QUESTIONS AND ANSWERS:

MANDATORY SITE VISIT DATE: SEPTEMBER 12, 2013 TIME: 1:00 P.M. (1300 Hours)
FILE NO: 7345-OR-EQ754.141004
CONTRACTING OFFICER: SHEILA DHANNA 416-512-5855
PROJECT MANAGER: ATIF SUHAIL 613-736-2886
TENDER CLOSING DATE: SEPTEMBER 24, 2013
SOLICITATION NO: EQ754-141004/A PROJECT NO: R.063528.001
PROJECT DESCRIPTION/LOCATION: CAMPBELLFORD, ONTARIO. TRENT SEVERN-WATERWAY. HEALEY FALLS LOCK 15. CONCRETE REFACING.

ELEVATION, BOTTOM STOP LOG
SCALE 1" = 3'-0"

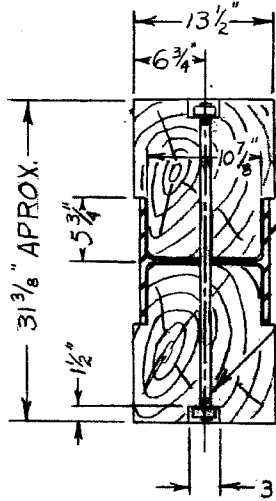
Q: Please provide the weight and dimensions of the stop logs.

A: Stop logs are 13.5" (34.3cm) wide x 31.375" (79.7cm) high x 35' (10.7m) long. Their weight is approximately 6,475lbs (2,937 Kg) dry and up to 8,000lbs (3,629 Kg) wet. Please see attached drawing for further details.
